Central Zoo Authority

F. No. 19-123/93-CZA(267)(Vol. I)(NS)/6944

Sub:- Designs for the proposed construction of enclosures at Malsi Deer Park, Dehradun, Uttarakhand - Reg.

With reference to the above cited correspondence, this is to inform you that the designs submitted for the proposed construction of enclosures at Malsi Deer Park, Dehradun, Uttarakhand were placed before the members in the 58th & 59th meeting of the Expert Group on Zoo designing held on 19th & 26th February, 2015 respectively and following observations have been made:-

STRIPPED HYENA ENCLOSURE	
CODE	PROJECT
XXX	DEHRADUN MINI ZOO @MALS!

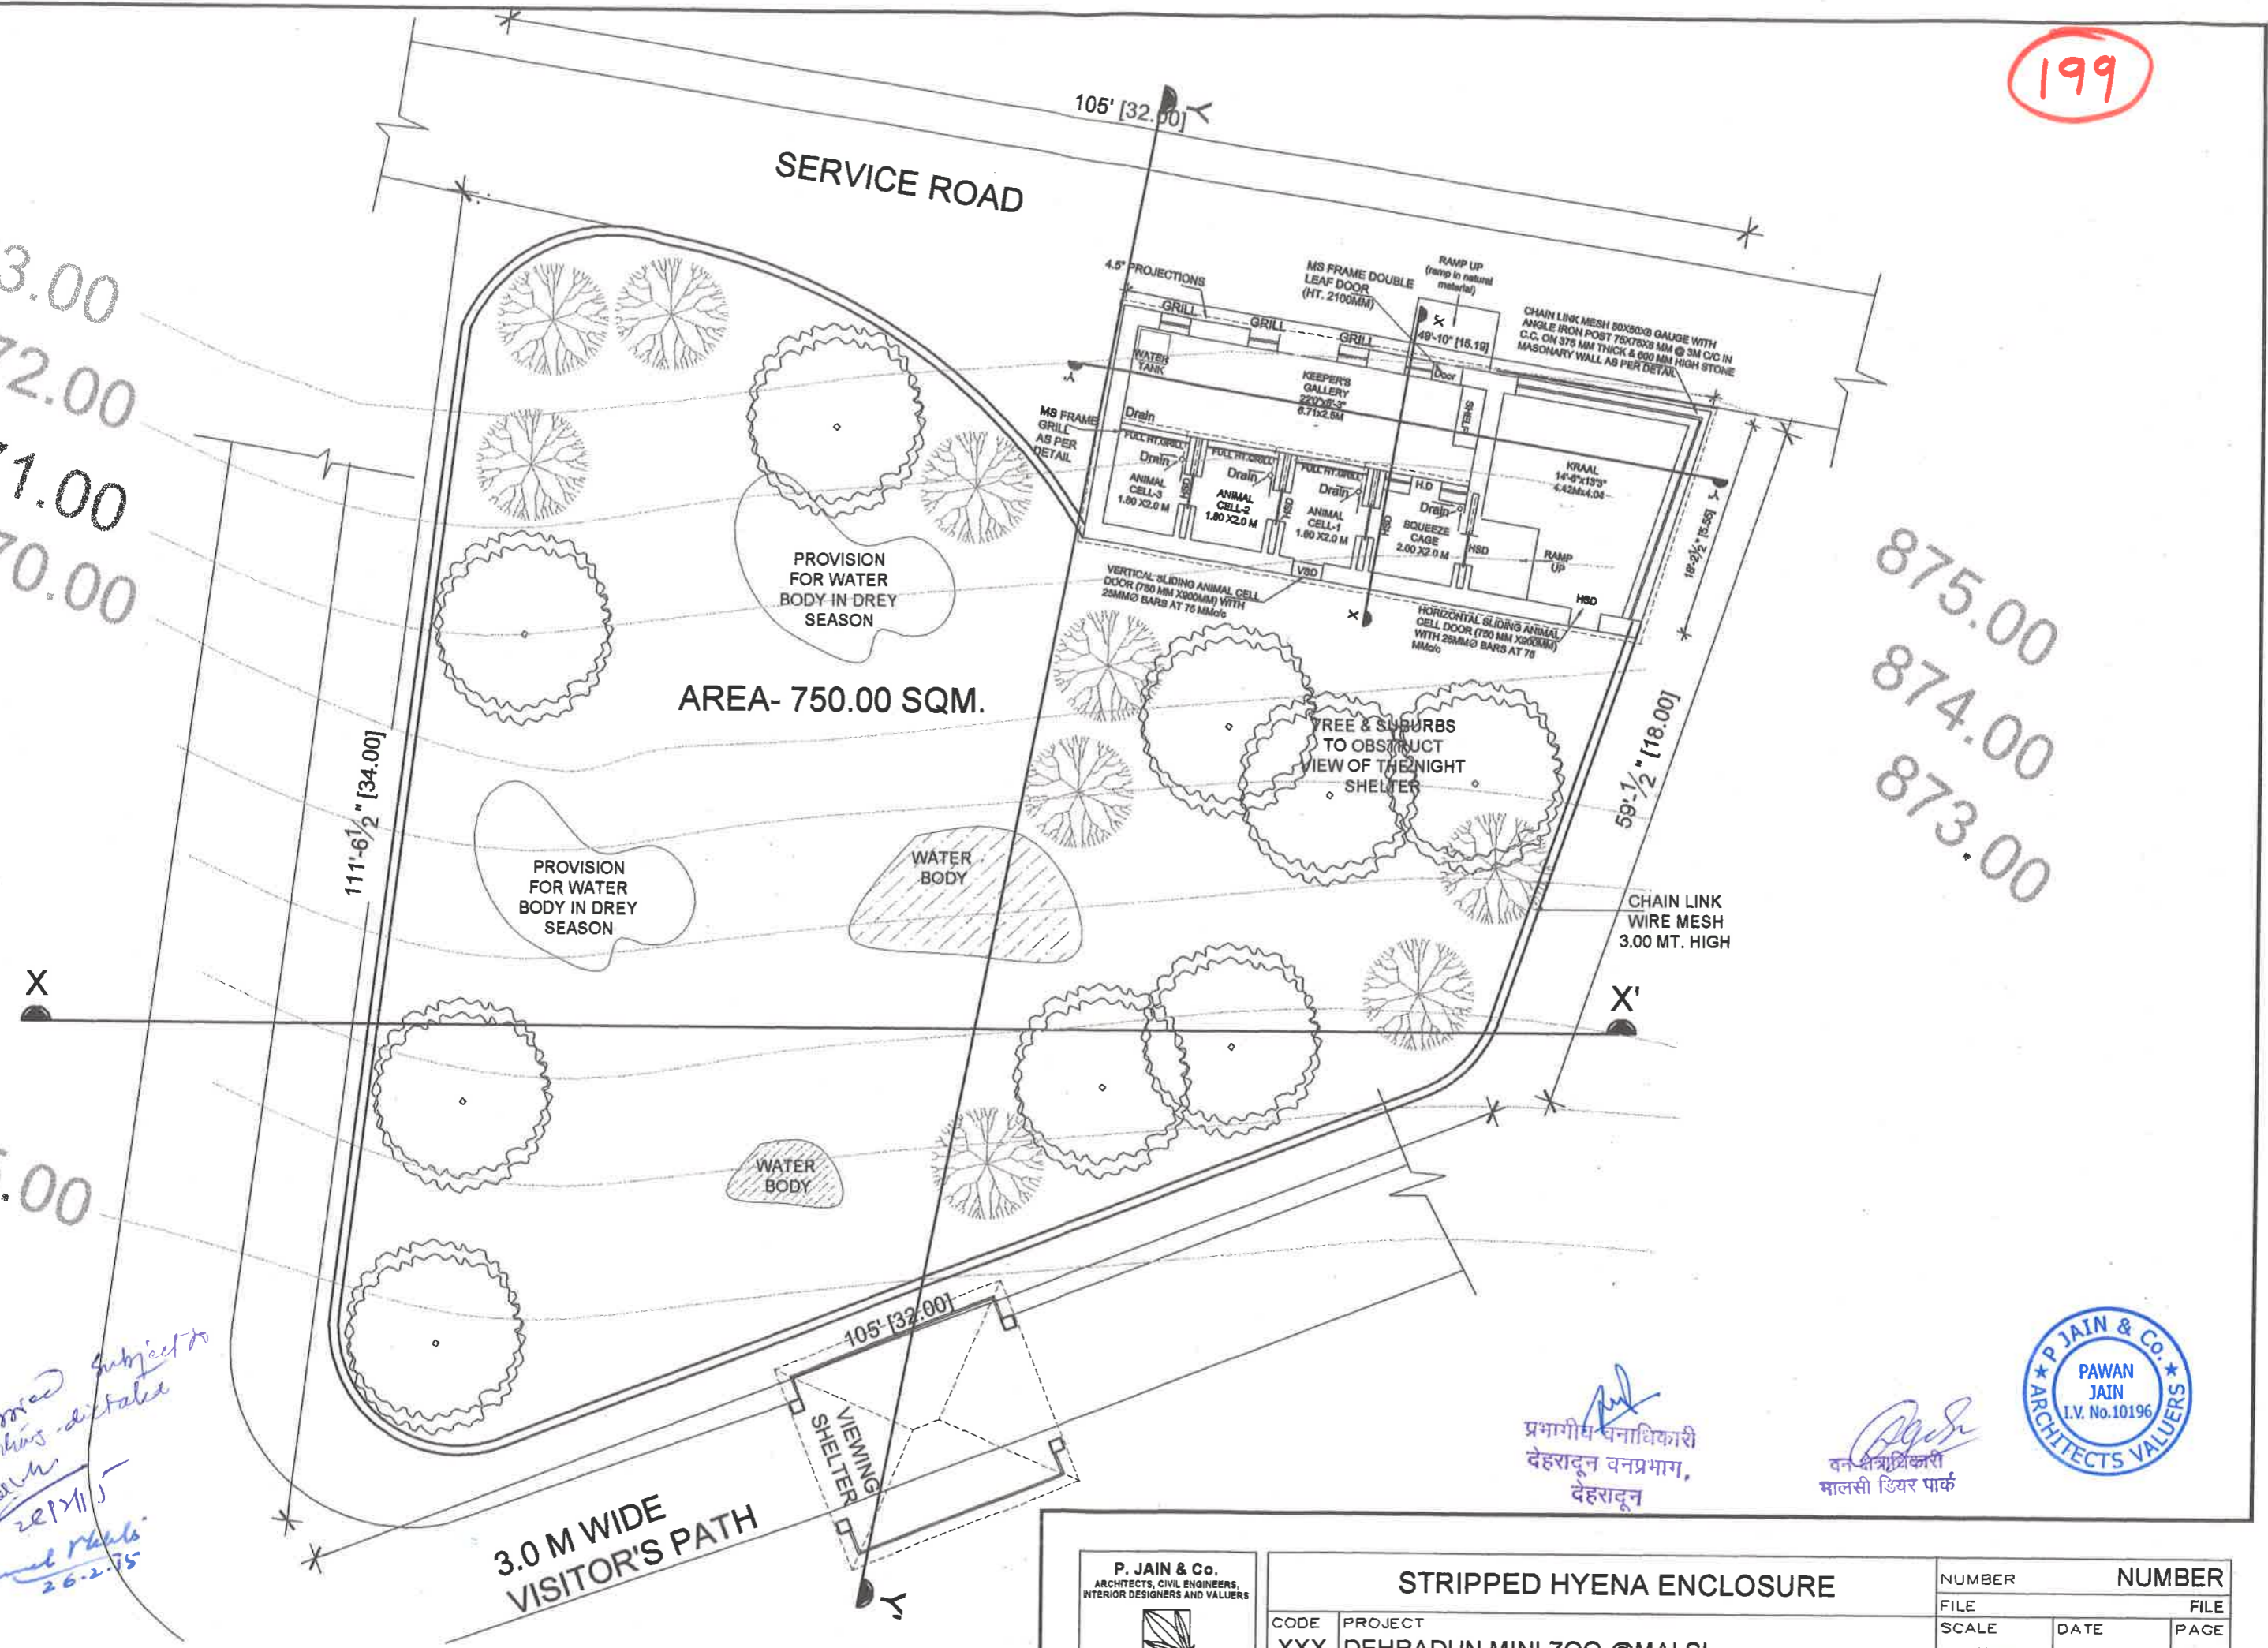
C. Construction of enclosure for Striped hyena:

The design was scrutinized and approved subject to compliance of following conditions:

- Size of smaller water body may be increased to that of the larger water body, as mentioned in the design.
- No viewing shelter is necessary. Plantation along visitors' path would serve the purpose.

*Be approved subject to the conditions stated
As per
28/11/15
Ramesh Rathi
26-2-15*
